**STATE SIGNIFICANT DEVELOPMENT
ASSESSMENT REPORT**

***Mixed Use Development at 80-88 Redfern
Street, Redfern***

SSD 7080

October 2017

Figure 11: Height and setback controls for the site with Regent Street's setback coloured purple and Marian Street coloured orange (Source: Draft UDG)

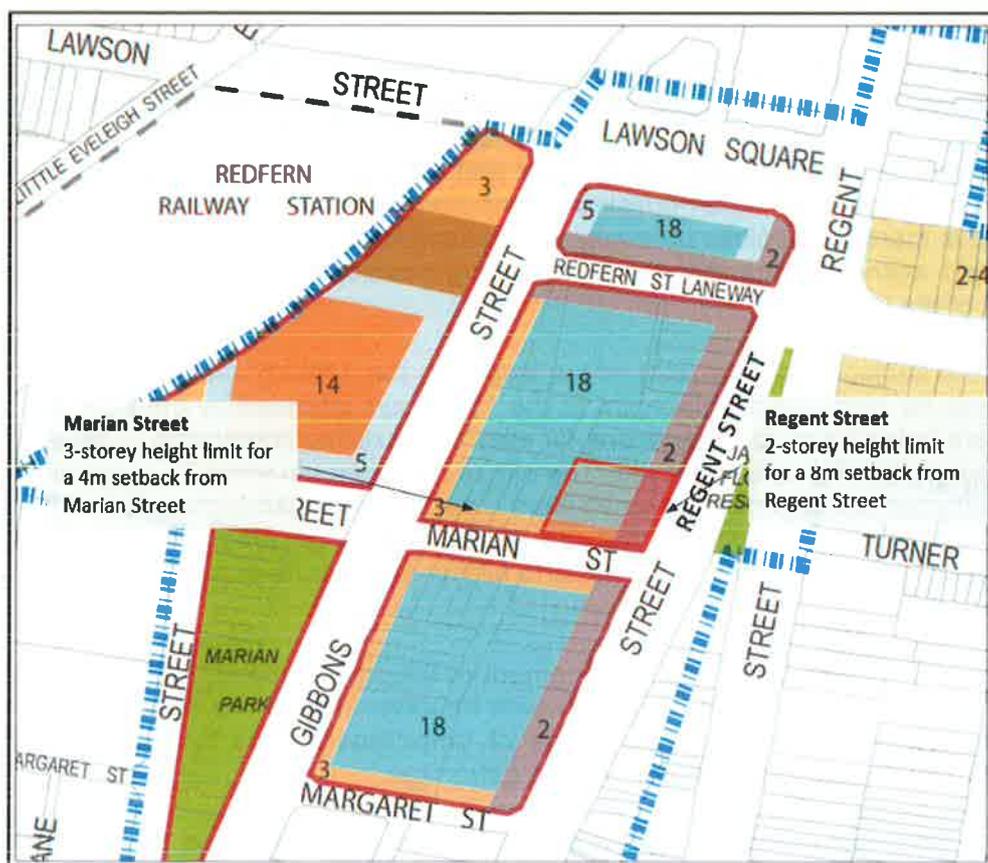
However, the proposal seeks to vary the setback standards to Regent and Marian Streets being:

- three metre setback from Regent Street for the 18-storey tower (rather than 8 m) above the two-storey street podium
- three metre setback from Marion Street for the upper part of the podium and the 18-storey tower (rather than 4 m) above the three storey podium
- providing a zero setback at the ground level (rather than the 1.5 m setback) on Marian Street.

The Department notes the design presents a two-storey podium form to Regent Street which is characteristic of the existing streetscape character. The provision of a 3 m setback for the 18-storey tower also provides a visual street presence consistent with the adjacent Iglu development. Given Iglu is a recent development directly adjacent to the subject site and was developed under the same planning controls, the Department considers the provision of consistent setbacks for the proposed development to be entirely compatible with achieving an appropriate design outcome for the site as it presents to Regent Street.

Noting the identified constraints of the site, the Department considers alternative setbacks represent a reasonable design response for the corner location of the building consistent with the emergent character of the Redfern Town Centre.

Figure 12: Relationship of podium to adjacent development (Source: RRTS).

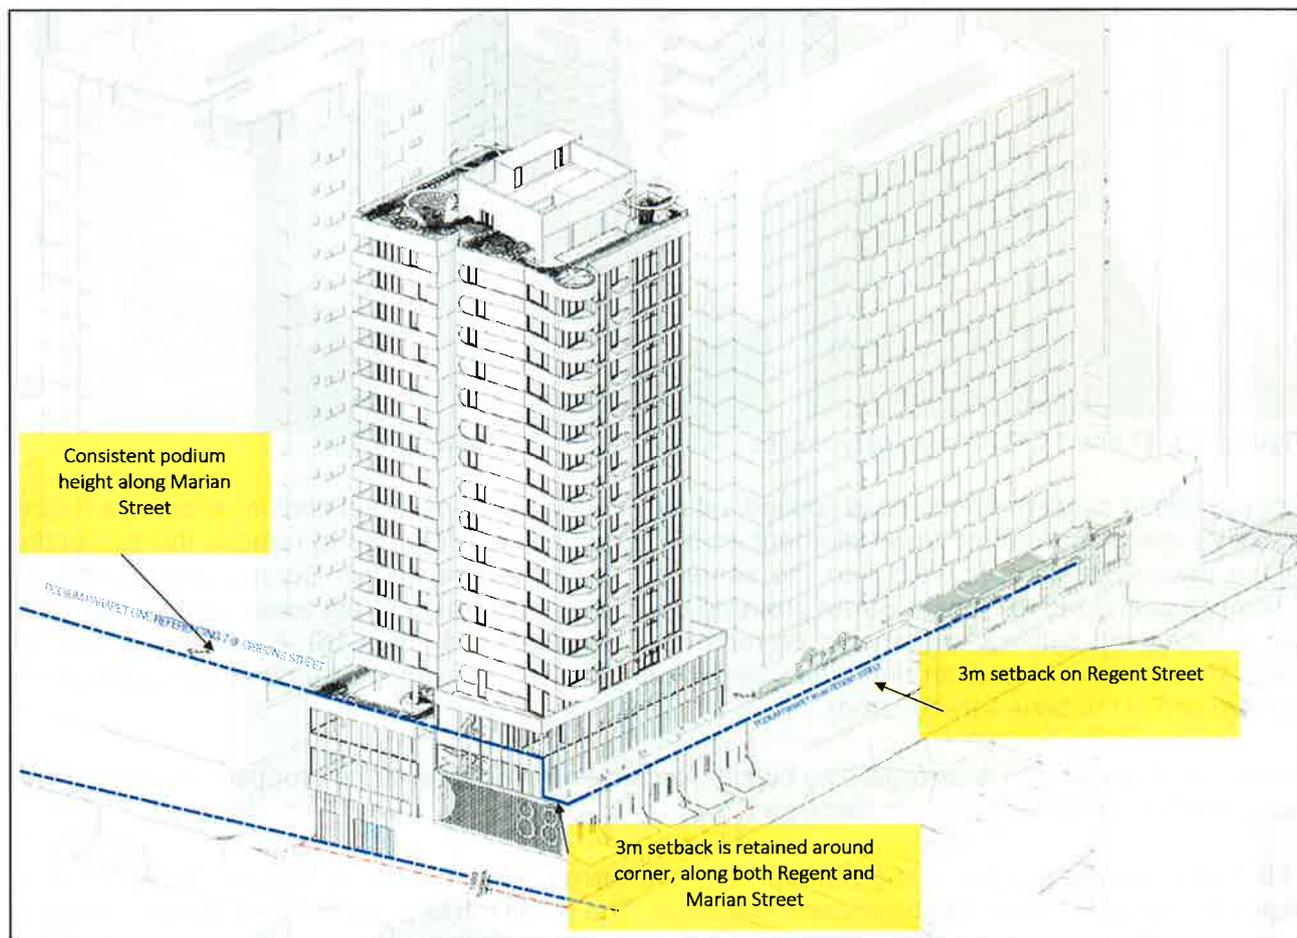
Council raised concern about the proposed setback noting the upper level podium should be further visually separated from the tower element on the Regent Street frontage to remove the perception of the tower extending forward into the same plane as the street wall. Council also stated the balconies orientated to Regent Street protrude beyond the alignment of the tower, inconsistent with the predominant setback and should be removed (**Figures 13, 14 and 15**). Furthermore, Council noted that due to the podium on Marian Street being built to the street boundary, the tower will sit forward of 7-9 Gibbons Street (Urba).

The Department further considers the design of the podium modulates its mass and is an appropriate architectural response to delineate between the various commercial and residential uses at the corner of the building.

Figure 17: View impacts from adjacent residence, Apartment D Urba, 7-9 Gibbons Street from view line no.1 (Source: Applicant's RtS)

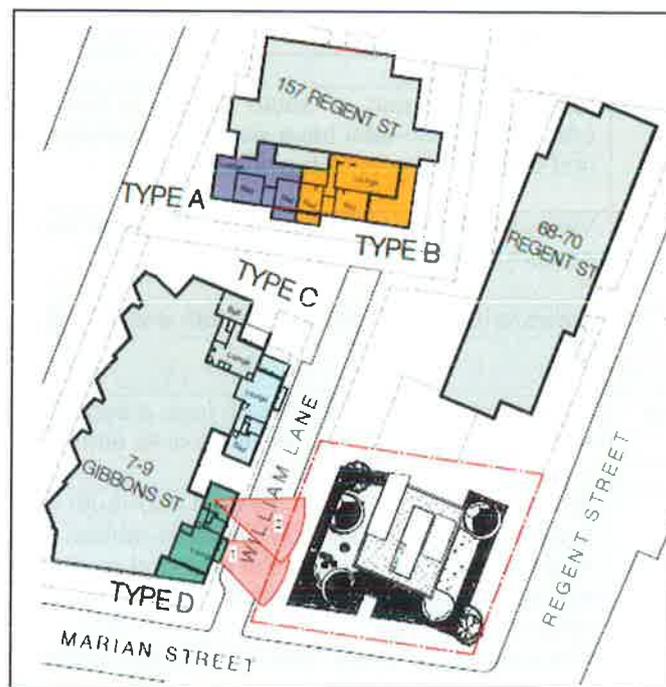
The Applicant contends the proposal provides a slender tower form within the 18-storey height limit and density controls envisaged for the site, and as such some impact on views is inevitable.

The Applicant further considers adherence to ADG building separation recommendations would not alter view impacts to neighbouring buildings and full compliance with setback controls would result in only a marginal change to the easterly view impact of some apartments within Urba.

Figure 20: Yellow area illustrates overshadowing at 9am, 12pm and 3pm at midwinter (left to right). Red dashed line illustrates impacts of a complying scheme (Source: Applicant's RRTS)

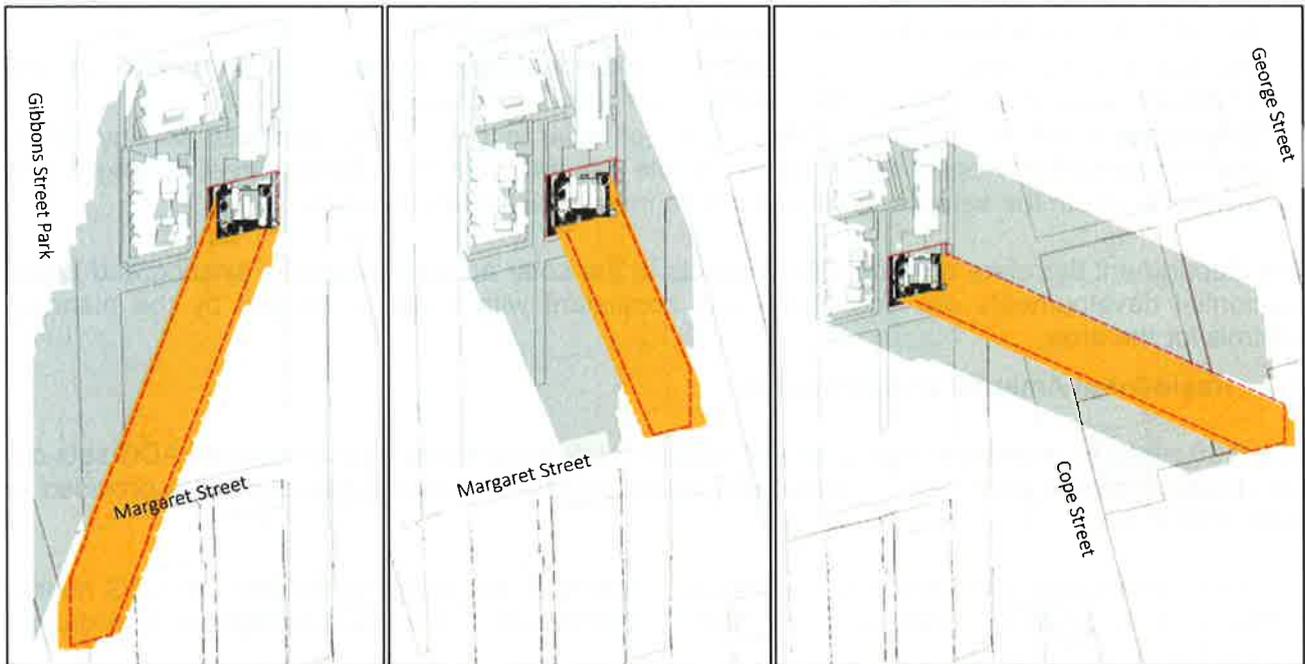
Council also queried that whilst the planning controls for the area envisaged an 18-storey building, additional impacts from the reduced setbacks should be carefully assessed and limited to controls established in the SSP SEPP, BEP and Draft UDG controls. Council also raised concerns on overshadowing impacts to the conservation area between Cope Street and George Street, Gibbons Street Park and residential development at 1 Margaret Street.

The Applicant has provided an overshadowing/ solar access analysis of the proposed development compared to the impacts from a complying scheme (**Figure 20**). The Applicant submits the overshadowing impacts from the proposed development are generally consistent with those envisaged by the planning controls for the site and are appropriate for a densely developed area to achieve the envisaged planning outcomes for the area.

The Department considers the extent of overshadowing is consistent with a fully compliant scheme (in terms of height and setbacks) with the exception of slivers of increased overshadowing on the eastern, southern and western sides of the proposed tower shadow envelope arising from the proposed minor variations to setbacks and roof top plant. (see **Section 5.3.2**).

Increased overshadowing to 1 Margaret Street and any future development to the south of the site will be generally consistent with a fully compliant scheme. The Department considers the variations, as indicated in **Figure 20**, to be minor and fleeting with shadowing only occurring to non-sensitive locations after 11 am. The Department further notes the block to the south, between Marian Street and Margaret Street, is also subject to an 18-storey height control.

Figure 21: Building separations of the proposal and of the directly adjoining developments. (Source: RtS)

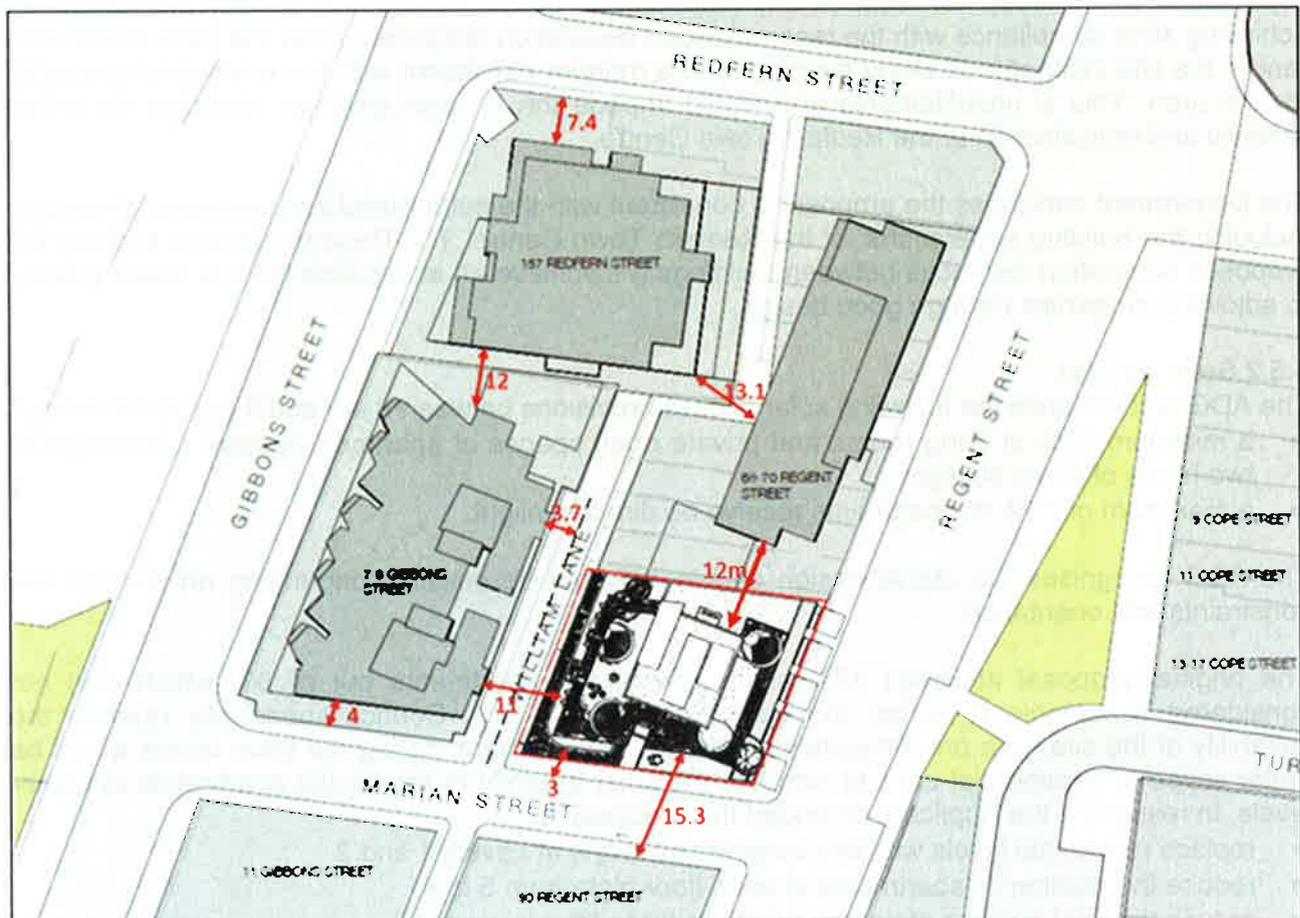
Fifty-four per cent of the public submissions raised concerns about the insufficient building separation between the proposal and the existing Urba and Diecota Buildings. Concerns were also originally raised by Council, representatives of the Iglu building to the north and from the 90-96 Regent Street site, located on the southern side of Marian Street.

During the exhibition, representatives of the Iglu Building requested increased setbacks to the northern boundary to ensure appropriate visual privacy. The potential developments at 90 Regent Street (south of Marian Street) also requested a minimum 4 m setback to Marian Street in order to achieve a 9 m setback from the centreline and 18 m separation potential between buildings.

The Applicant contends that although the recommended ADG building separations are not proposed to be achieved, visual privacy will nevertheless be retained through the inclusion of the following treatments:
